Product / Process Change Notification (PCN)

PCN #: PCN_WCAP-FTDB_20230826

Affected Series: WCAP-FTDB;
 P/N 890724427010CS

New Drawing with new size tolerance in datasheet 890724427010CS

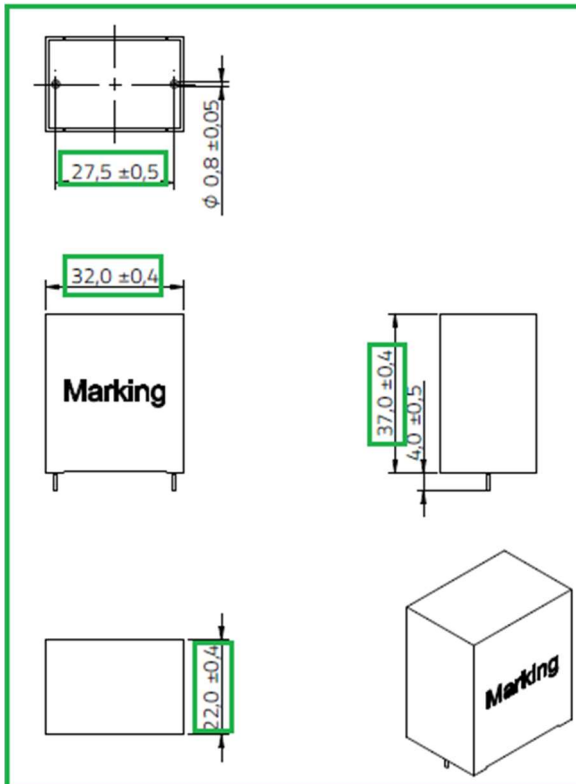
- Würth Elektronik will correct the **pitch tolerance** from "**27.5 ± 1.0**" into "**27.5 ± 0.5**".
- Würth Elektronik will correct the **length tolerance** from "**32.0 ± 1.0**" into "**32.0 ± 0.4**".
- Würth Elektronik will correct the **width tolerance** from "**22.0 ± 1.0**" into "**22.0 ± 0.4**".
- Würth Elektronik will correct the **height tolerance** from "**37.0 ± 1.0**" into "**37.0 ± 0.4**".

Below is the specification of change for P/N 890724427010CS, old and new drawings are shown below in order to visualize the updates of the tolerance.
